Research Report 1524

MANPRINT Evaluation: AN/TRC-170 Digital Troposcatter Radio System

MANPRINT EVALUATION: AN/TRC-170 DIGITAL TROPOSCATTER RADIO SYSTEM

Figure 18. An example of the type of manipulation task that could be performed more rapidly by crewmen using a stepladder or platform.

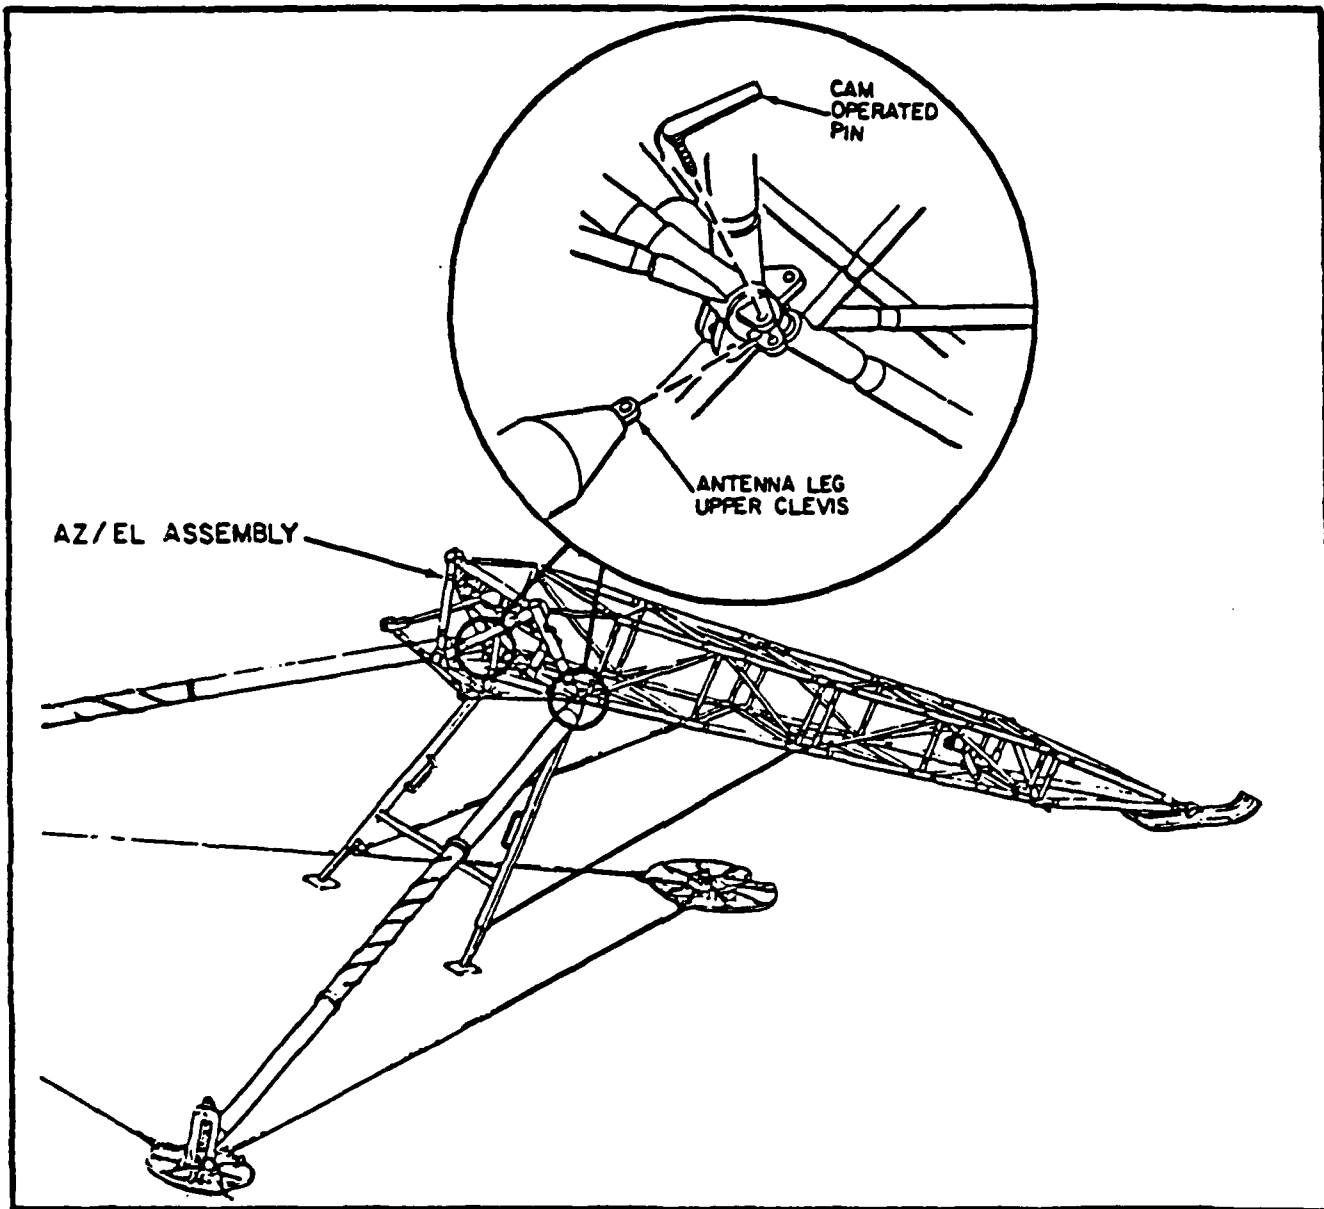
Description of the Problem: Figure 18 shows the type of manipulation task that must be performed on the 9.5-ft antenna. Figure 19 shows the antenna hand crank that is difficult to reach. The assembly of the 9.5-ft antenna has several situations where personnel need to extend their reach. There is no ladder or other approved stand available on the AN/TRC-170. The situations include the following:

Potential Solutions: Provide a stand as standard equipment issue for the AN/TRC-170(V2). It is recommended that at least a 3-ft high stand or ladder be supplied.

Figure 20. The interior of the low-profile pallet showing the location of the accessory alignment kit.

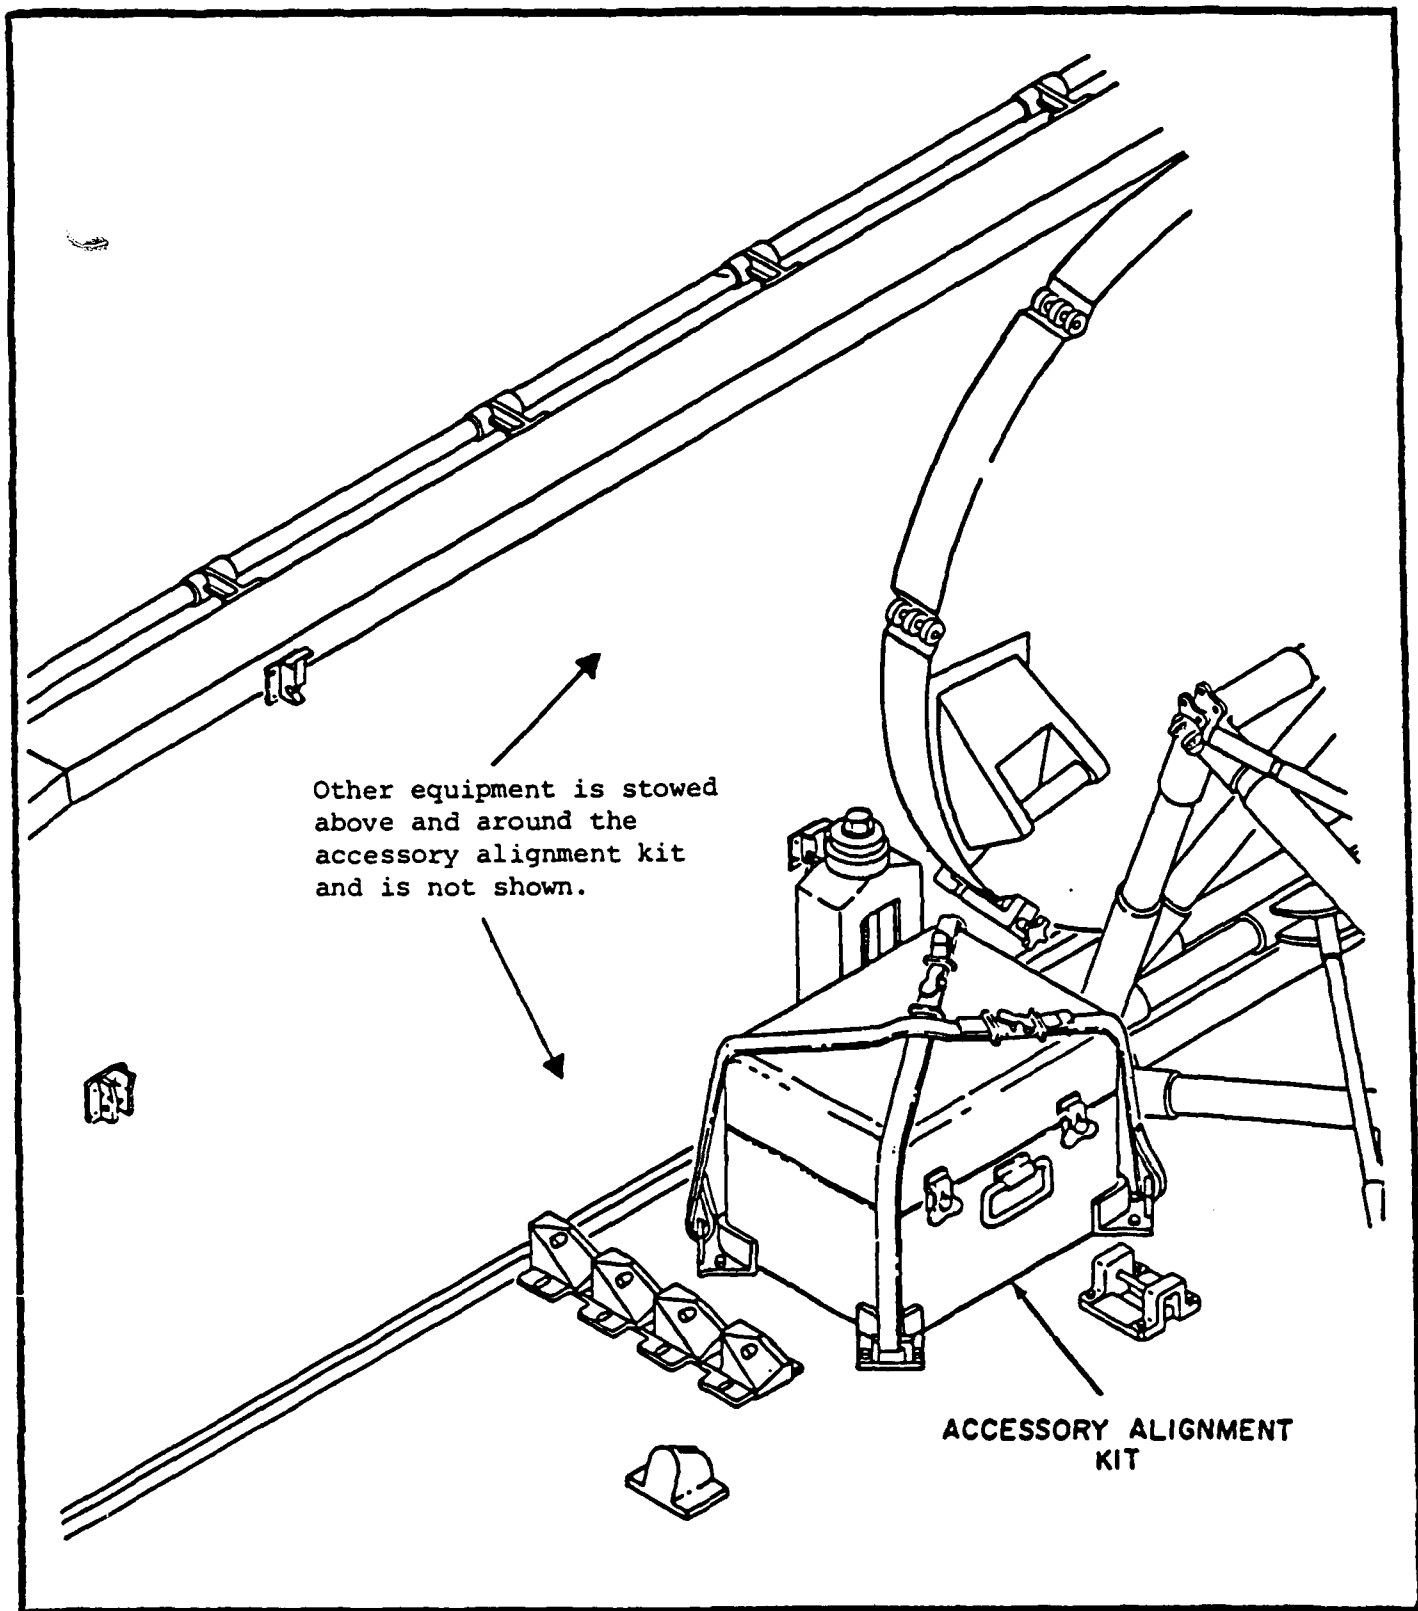
Description of the Problem: Figure 20 shows the location of the accessory kit on the low-profile pallet. The location of the accessory kit, which includes the pocket transit on the low-profile pallet, is located on the bottom of the pallet beneath the antenna truss structures. The pocket transit is the first item needed for site layout. The crew must remove the canvas cover from the pallet and push antenna parts out of the way to retrieve the kit.

Potential Solutions: The accessory kit should be placed in the shelter near the door or in the truck cab area for easy access.

Figure 21. The low-profile pallet which was mounted on a 2.5-ton truck.

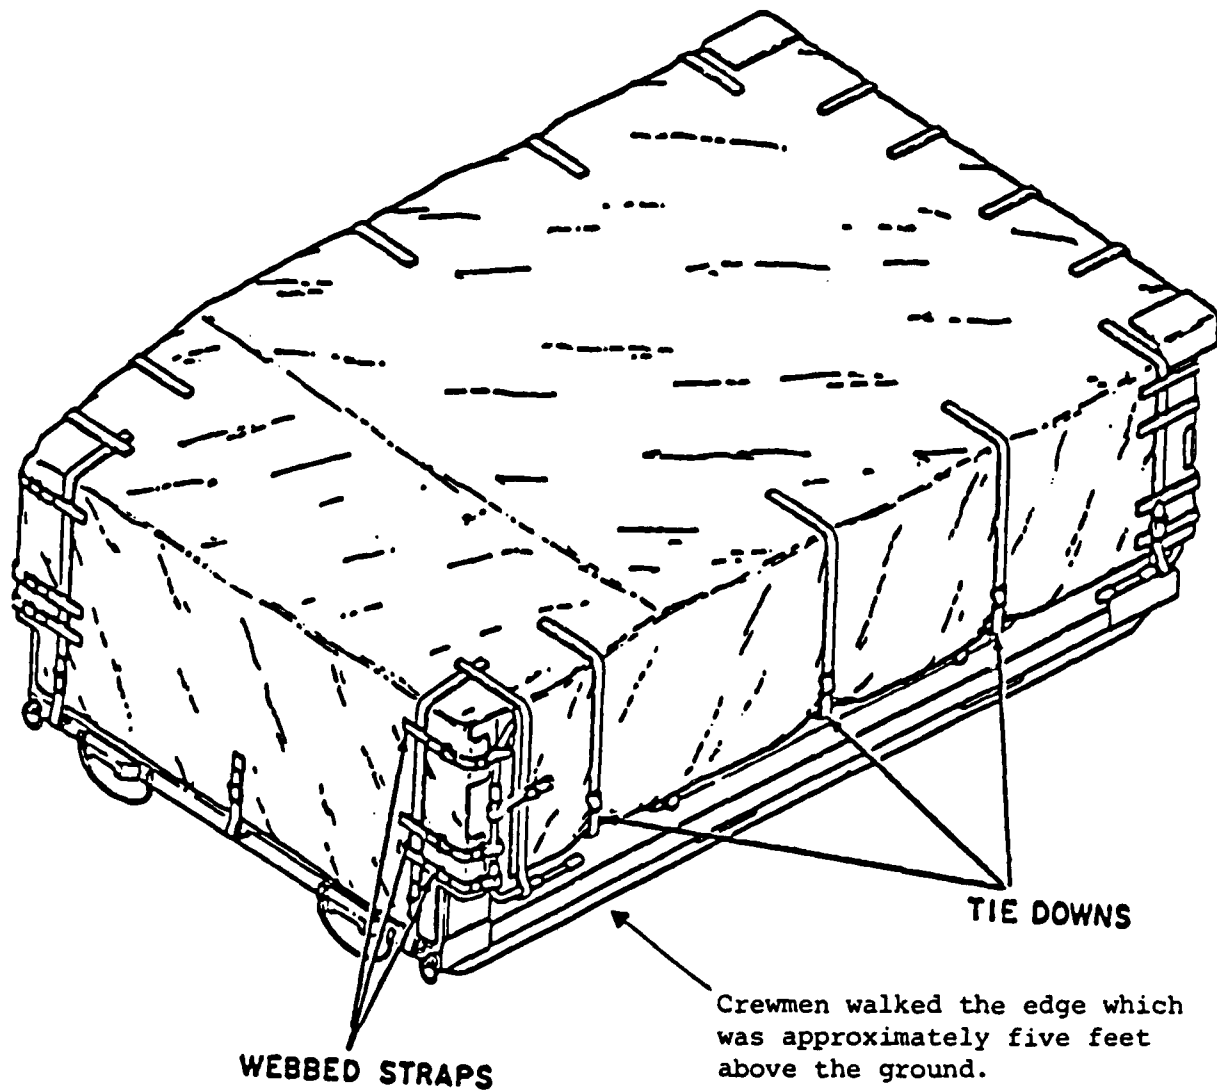
Description of the Problem: Figure 21 shows the low-profile pallet secured for transport. Crewmen must walk on the outside edge (3-in width) of the low-profile pallet in order to remove the canvas and ropes. Crew members must assume unsafe positions when removing the canvas cover and retrieving the accessory kit.

Potential Solutions: The canvas cover over the low-profile pallet could be provided with a drawstring arrangement so that personnel would not have to climb the side of the truck. The load on the low-profile pallet should be redistributed to facilitate loading and unloading, and consideration should be given to moving some of the load to the shelter.
